General File ID or BMP ID: YC016

Property Description: Norge Elementary School

NORGE SCHOOL SITE PLAN REVIEW COMMENTS; 1/25/94; WNB

CODE COMPLIANCE REVIEW COMMENTS
NORGE ELEMENTARY SCHOOL MODIFICATIONS
PLAN NO. SP-132-93
January 5, 1994 DEC

INFILTRATOR™ Chambers in 2 Layers

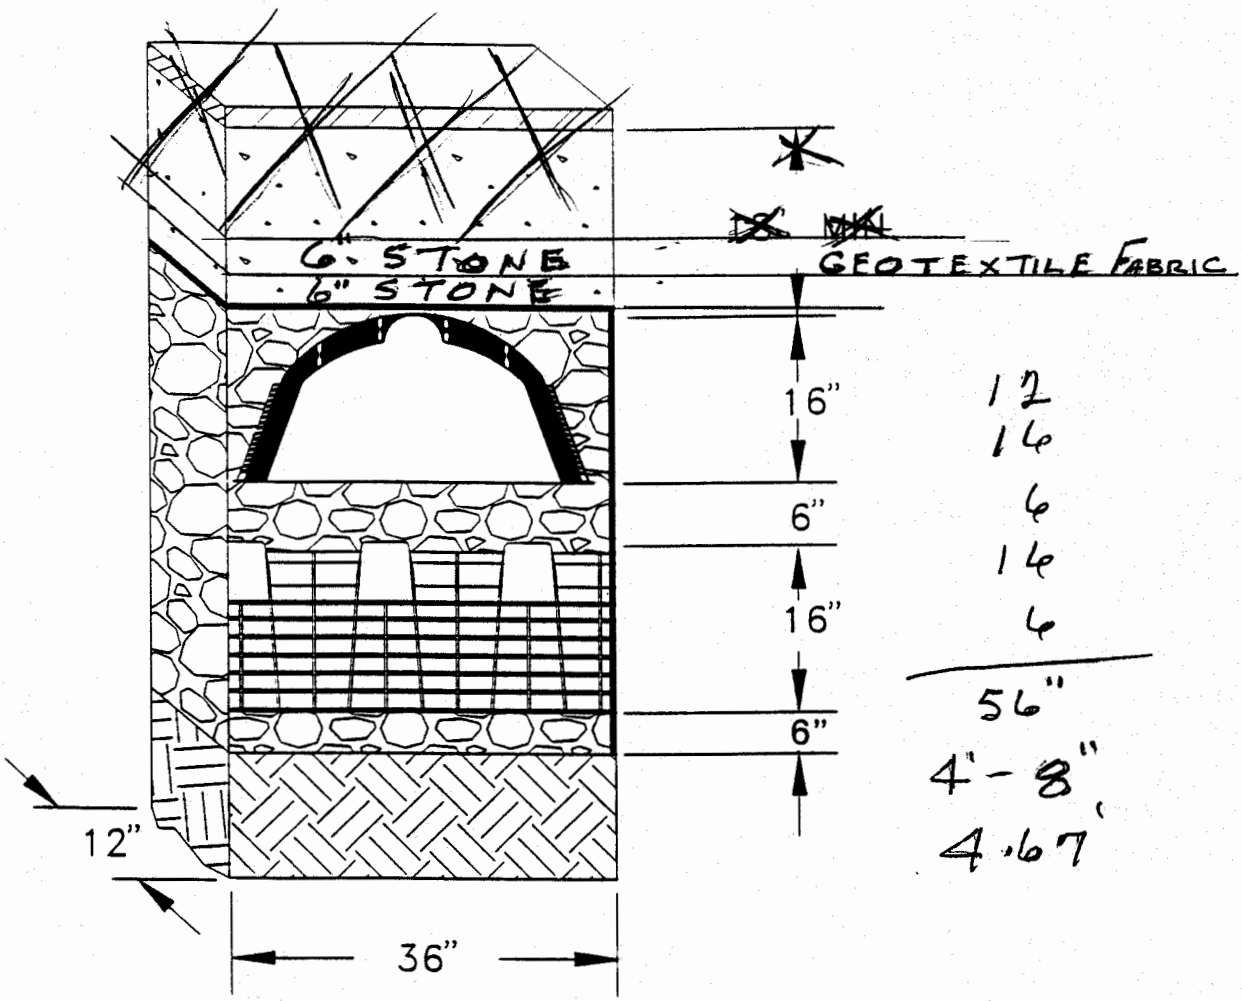
SUGGESTION; USEING HIGH CAPACITY " INFILTRATORS "/ STONE COMBINATION PER ATTACHED SKETCH WILL REDUCE TRENCH SIZE TO 100 FT X 62.5 FT X 4.67 FT.

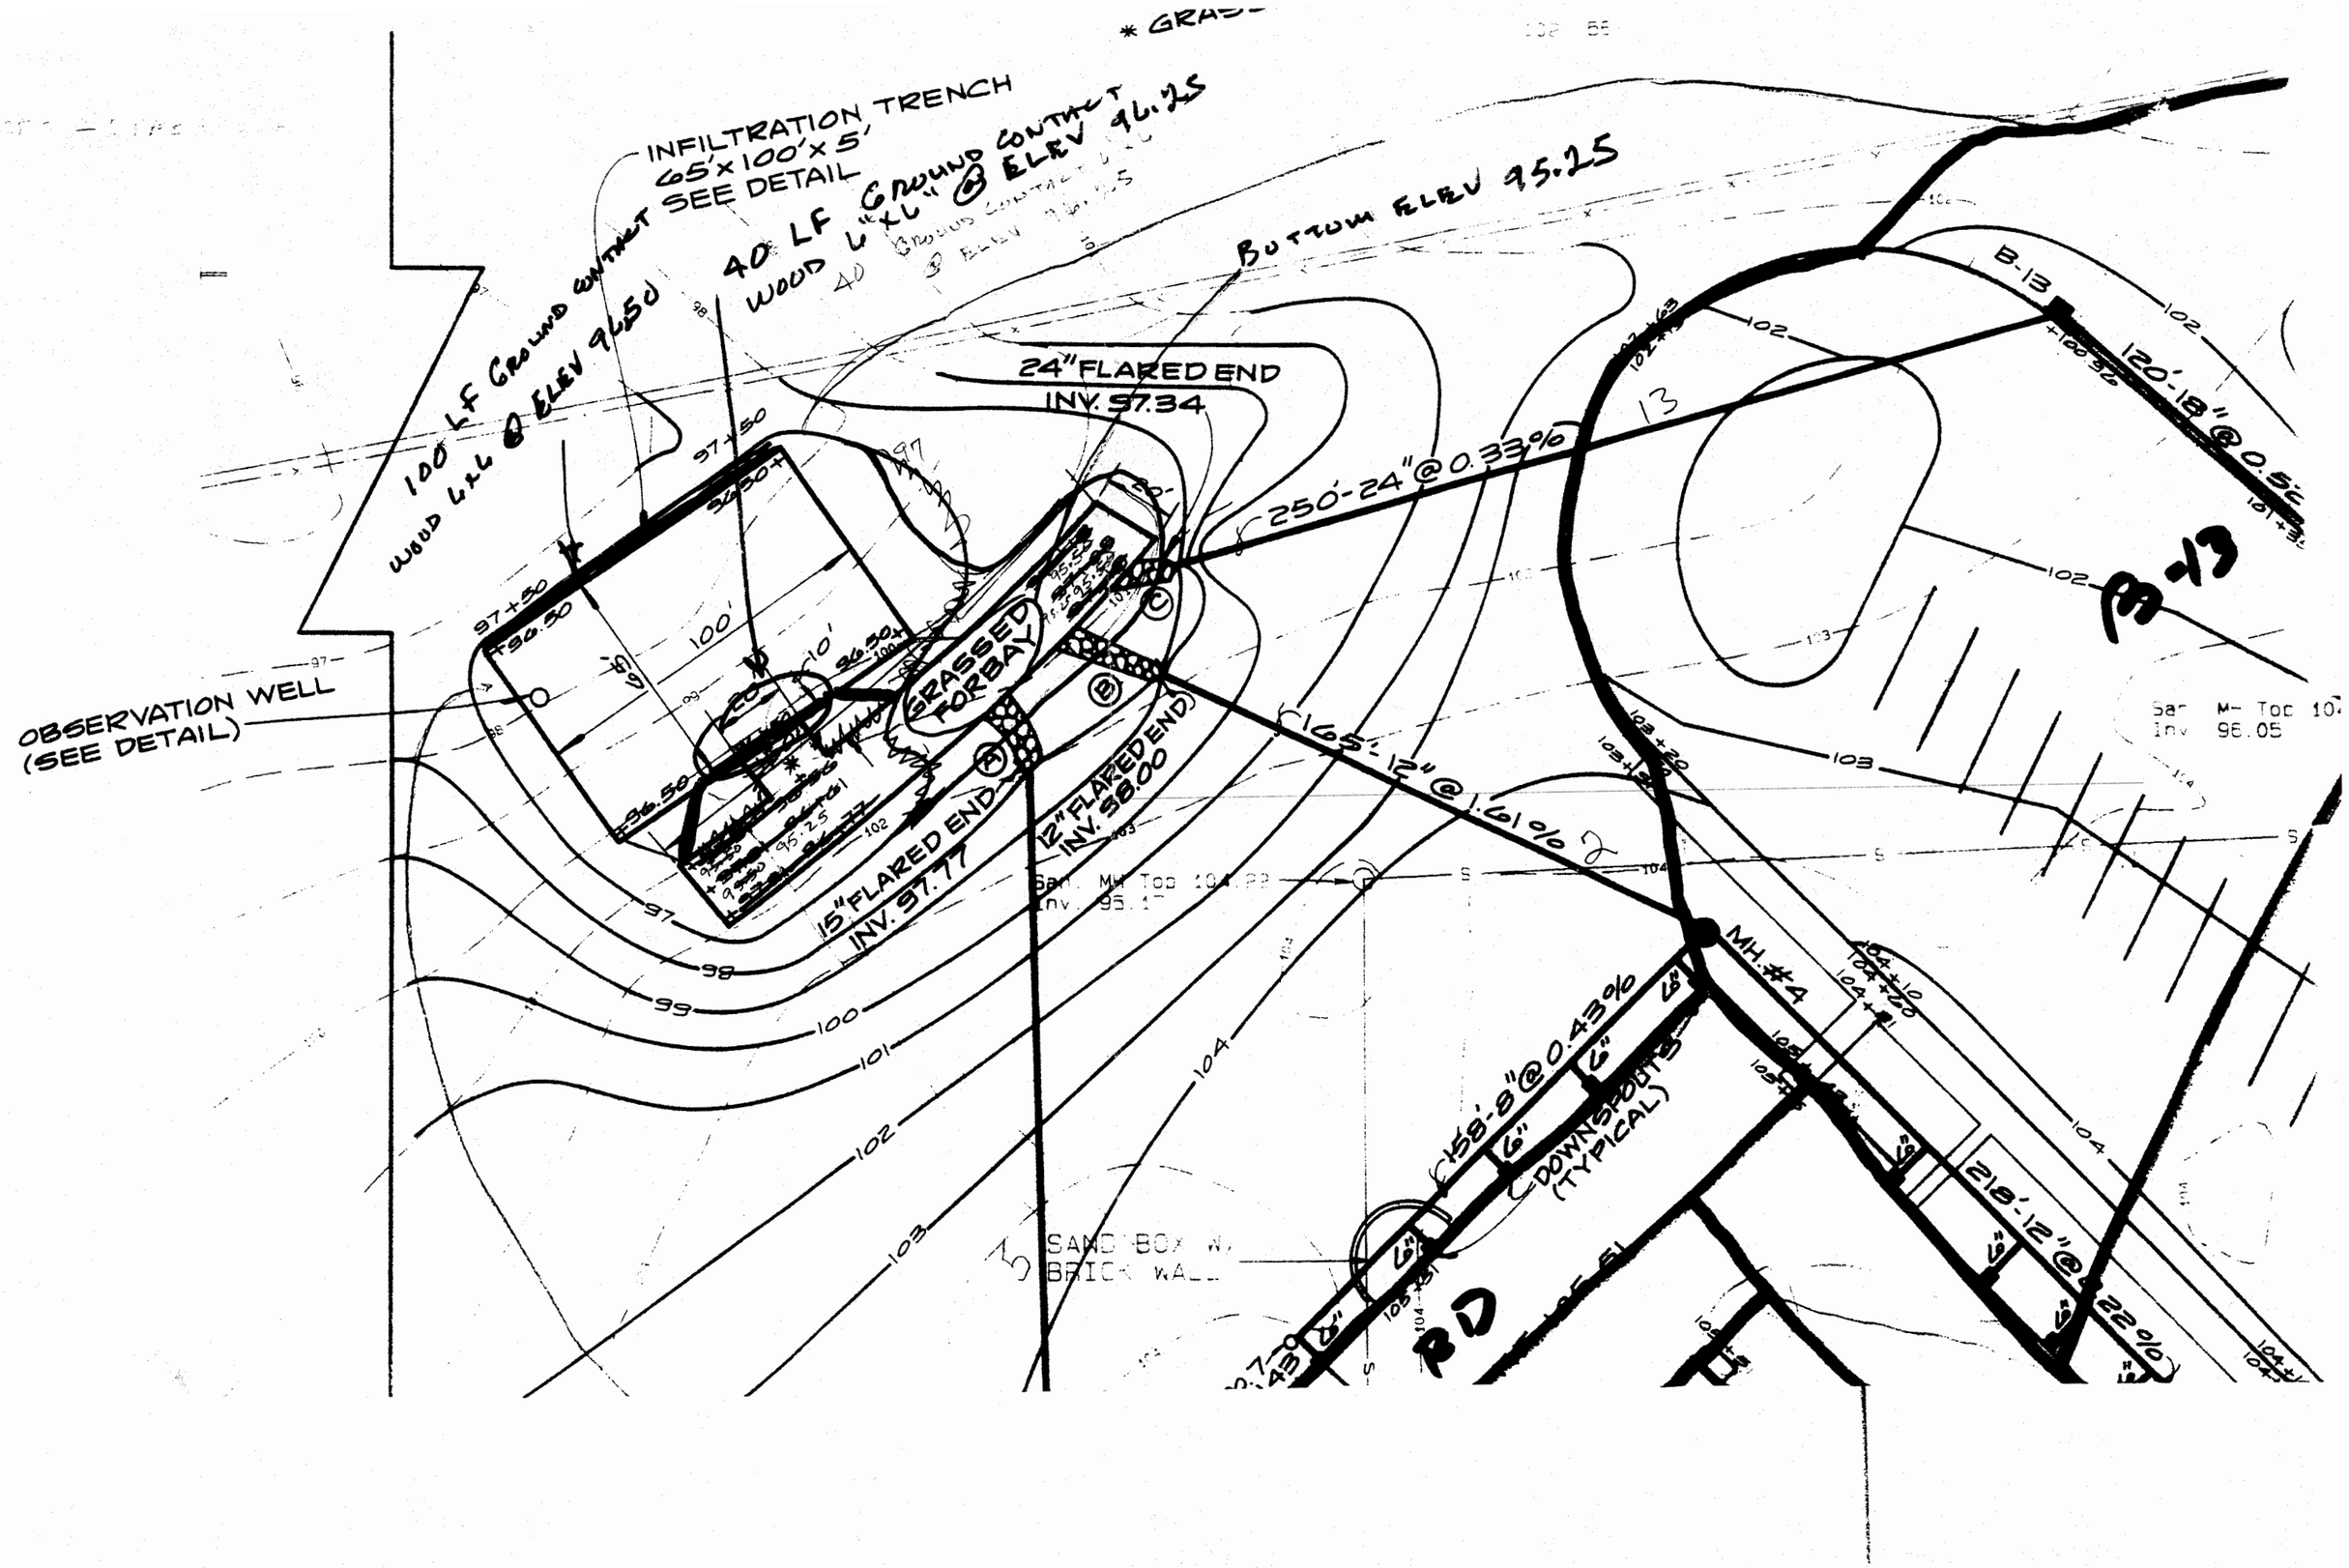
2. ADD 100 LF 6" X 6" WOOD GROUND CONTACT LEVEL SPREADER OUTFALL TO INFILTRATION TRENCH @ ELEVATION 96.50

3. GRASSED FOREBAY; RECOMMEND BOTTOM ELEVATION @ 95.25; RECOMMEND 40 LF OF GROUND CONTACT WOOD 6" X 6" TOP ELEV @ 96.25; SKETCH ATTACHED.

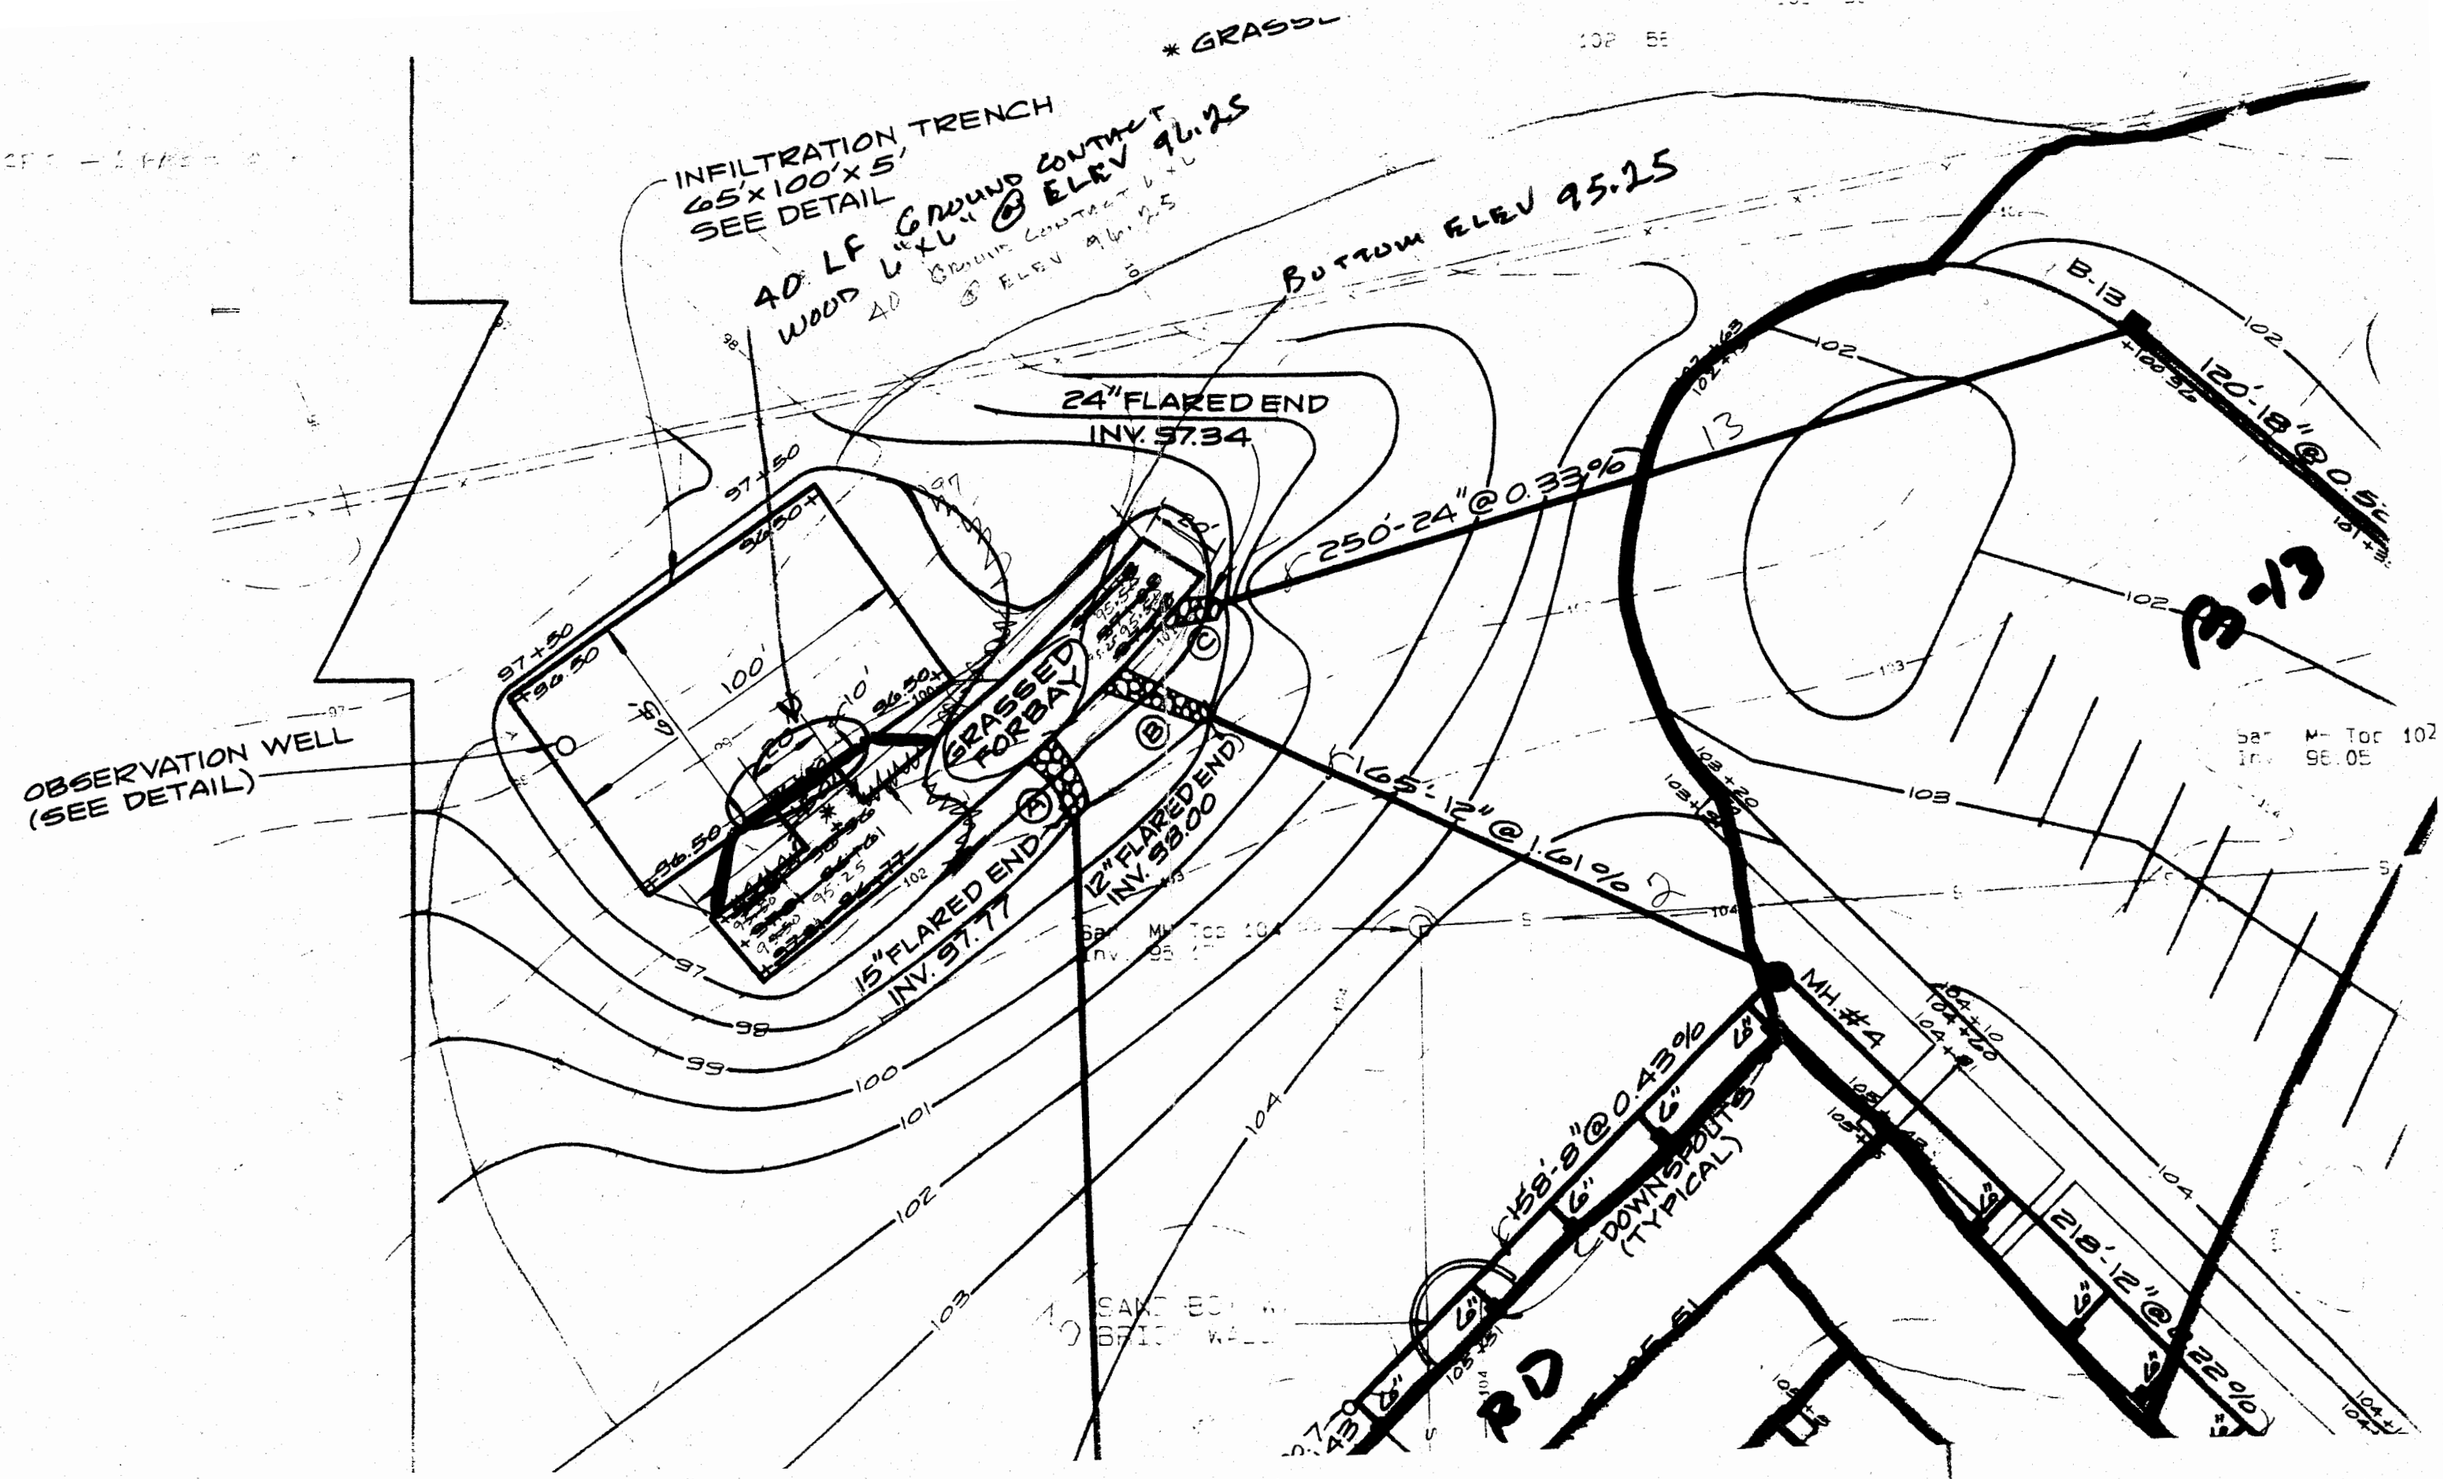
6. Instead of having open stone to the surface, cover the infiltration trench with a minimum of 6 inches of vegetated topsoil. The soil must be separated from the stone by filter fabric. Provide several small, polyethylene inlets connected by perforated pipe to allow water into and distributed within the trench. Revise the detail on C-9 as necessary.
